The Factors that Require the Replacement of LANL Monitoring Wells R-6 and R-6i

By Robert H. Gilkeson, Registered Geologist

Report on December 2, 2009

Figure 1. The location of monitoring wells R-6 and R-6i in the eastern part of TA-21

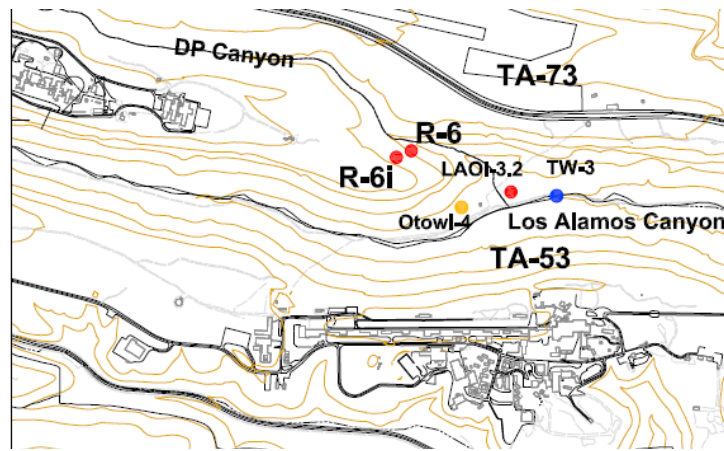
Introduction. Figure 1 shows the locations of LANL monitoring wells R-6 and R-6i in DP Canyon ¼ mile northwest of Los Alamos Canyon. Well R-6 was drilled in October of 2004 with the mud-rotary method that pushed a large quantity of drilling muds into the sampling zone for the well. The drilling muds were a mixture of bentonite clay and organic additives. The well development was not able to remove the majority of the drilling muds. The drilling muds created a new highly reactive mineralogy in the screened zone of well R-6 with well known properties to prevent the detection of many LANL contaminants including trace metals, organics, and the strongly sorbing LANL radionuclides including plutonium and americium. The 23-foot long well screen is installed from 1205 to 1228 feet below ground surface (ft bgs). The water table of the regional aquifer is at 1158 ft bgs. The top of the well screen is 47 feet below the water table and too deep to detect contamination at the water table of the regional aquifer.

Figure 1 on page 3 of this report shows that well R-6 is located west of drinking water well O-4 in the green zone on Figure 2 where alluvial sediments are contaminated with high concentrations of isotopes of plutonium, americium and strontium.

The regional aquifer monitoring wells in the above list are wells R-5, R-7, R-8, R-9 and old test well TW-3. Monitoring well R-6 was installed to replace well TW-3. The locations of wells R-6 and TW-3 are displayed on Figure 1. All of the wells are displayed below on Figure 4. However, it is very important to understand that **none** of the six regional aquifer monitoring wells listed in the NMED Consent Order are at appropriate locations for monitoring groundwater contamination beneath MDA T or the other legacy waste MDAs at TA-21. The lateral distances from the center of MDA T to the inappropriate monitoring wells listed in the NMED Consent Order are summarized below:

The physical facts are proof that only a small portion of the bentonite clay and organic additives were removed from the aquifer zone from which well R-6 produces water. Well R-6 requires replacement with three new monitoring wells that are drilled with the correct application of the dual-rotary casing advance drilling method using only air or potable water as drilling fluids. One well shall be installed near the water table of the regional aquifer, the second well shall be installed in the first aquifer zone with high permeability and the third well shall be installed at an appropriate depth in the regional aquifer as a sentry well for the drinking water supply well Otowi-4. The location of well Otowi-4 is displayed on Figure 1. The pair of R-35 monitoring wells that were installed as sentry

Figure 2. Figure 5-11 in *Environmental Surveillance at Los Alamos During 2008*

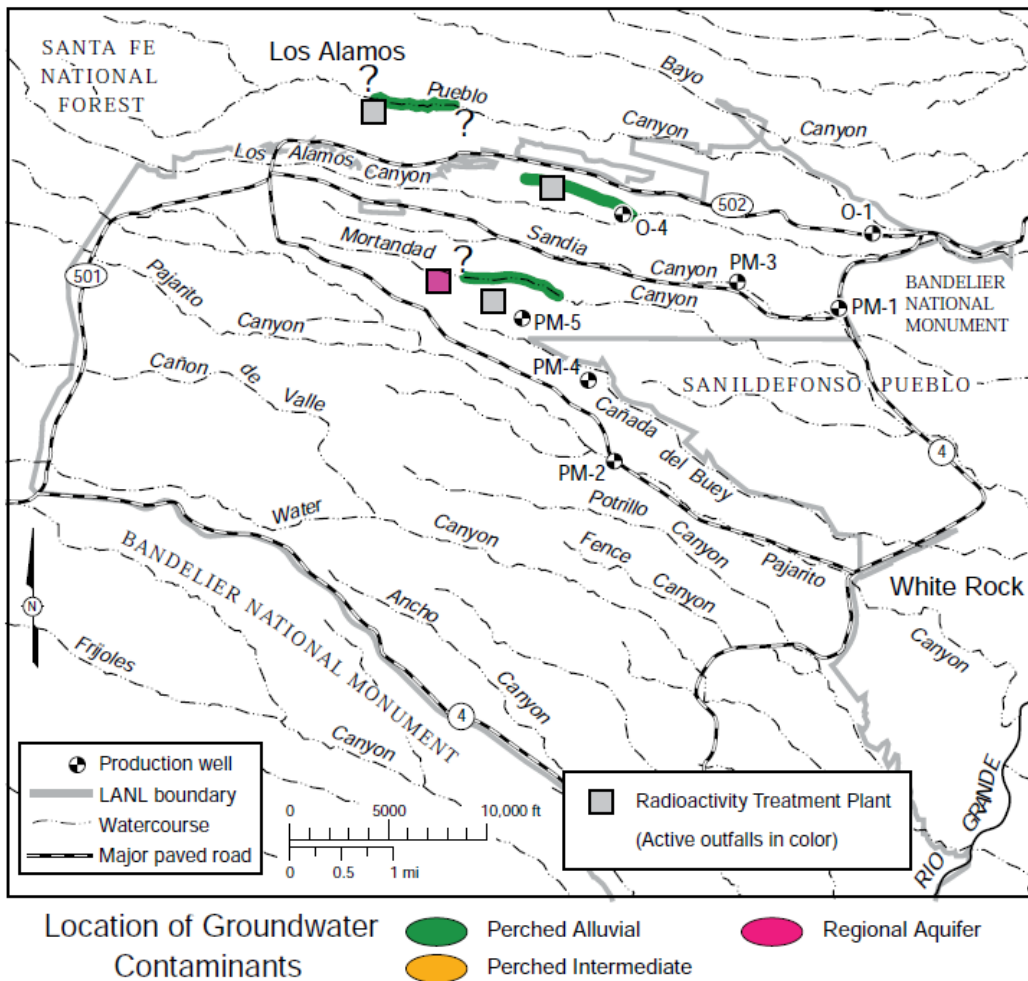
The mud-rotary monitoring well R-6 is not reliable for detection of LANL contamination present in the wet alluvial sediments present in DP Canyon and Los Alamos Canyon that have migrated to the regional aquifer. An important requirement at the location of monitoring well R-6 is accurate knowledge of groundwater contamination in the regional aquifer from the highly adsorptive radionuclide contaminants americium and plutonium and also strontium-90. These contaminants are measured in the groundwater samples collected from the water saturated alluvial sediments along DP Canyon east of TA-21 and at the confluence of DP Canyon with Los Alamos Canyon. The one mile long zone of radionuclide contamination in the alluvial sediments beginning at drinking water well O-4 and along DP Canyon west of the confluence with Los Alamos Canyon is displayed on Figure 2 on the next page.

Figure 3. (MDAs) at TA-21 and their SWMU numbers.

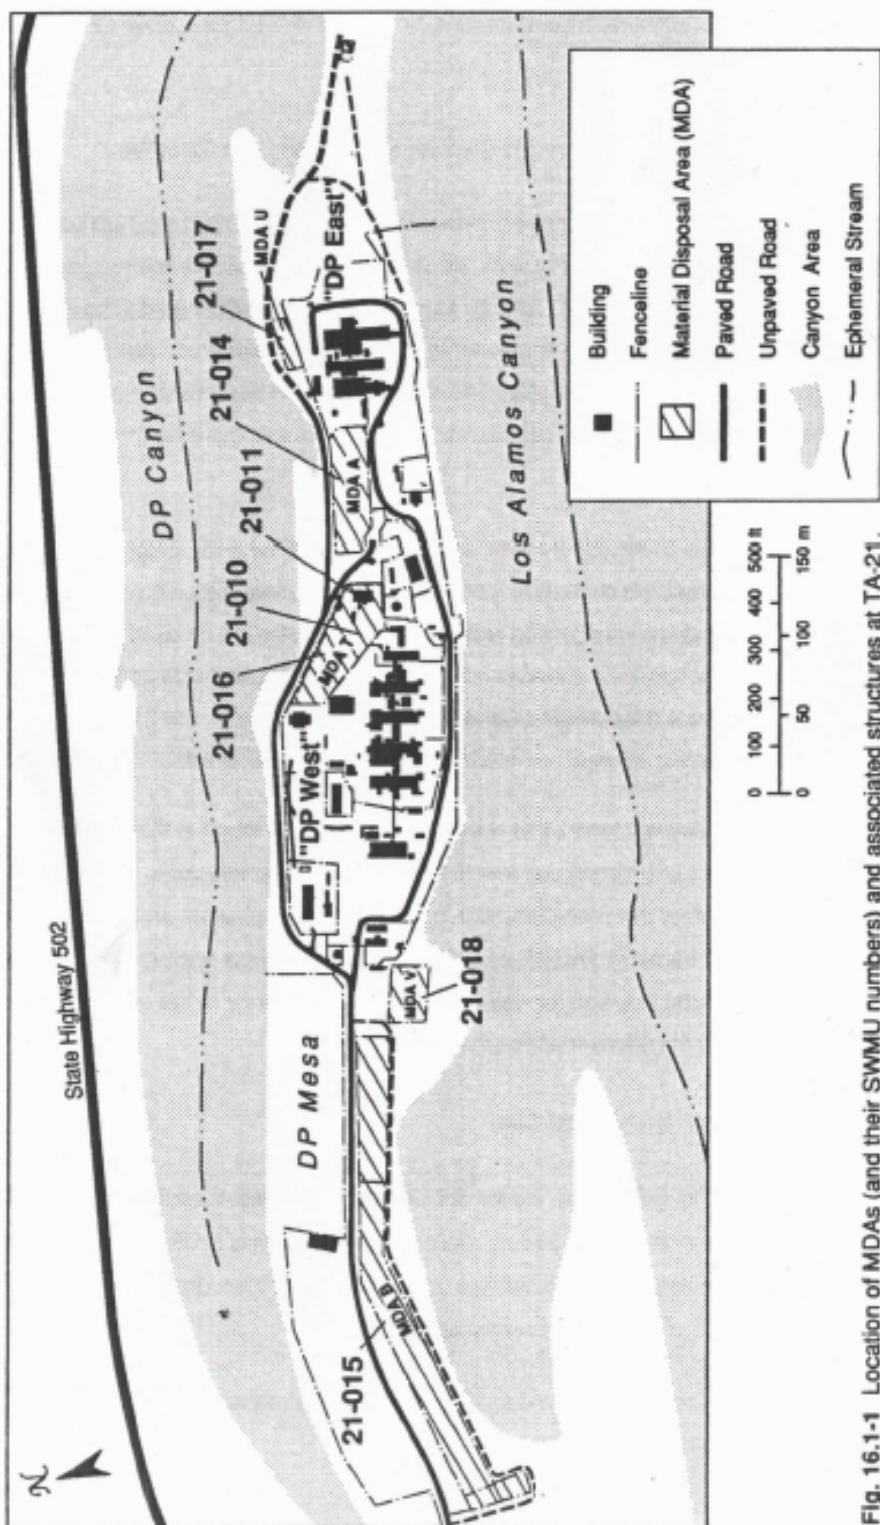
Well R-6 is too far away from the five legacy waste dumps (MDAs) at TA-21. Figure 3 on page 12 displays the locations of the five MDAs at TA-21. The direction of groundwater travel in the regional aquifer below TA-21 is from west to east toward monitoring well R-6. The necessary field tests to measure the lateral speed of groundwater travel in the regional aquifer below TA-21 have not been done. The best estimate of groundwater travel in the regional aquifer is described as follows in the LANL Environmental Surveillance Report that was published in 2008:

The locations of the five legacy waste dumps at TA-21 are displayed below on Figure 3. There is an immediate need to install an appropriate network of monitoring wells at TA-21 to investigate and monitor groundwater contamination from the legacy waste dumps and also from the other disposal sites at TA-21 where large volumes of liquid wastes were disposed of in seepage pits, disposal wells and sumps.
